Problem with "Single 4"

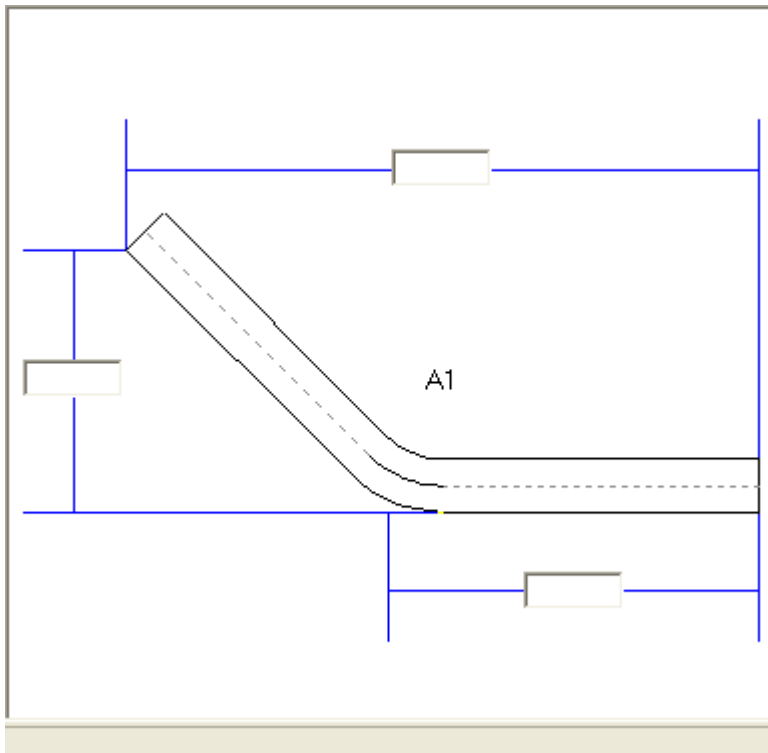
On some releases the logic for this template was incorrect. The bottom horizontal dimension was recognized as the distance from the left end of the part to the apex of the bend and not the right end of the part to the apex of the bend as drawn.

Please goto the template download window for an updated template list and the fix.
http://www.2020softwaresolutions.com/new_templates.htm
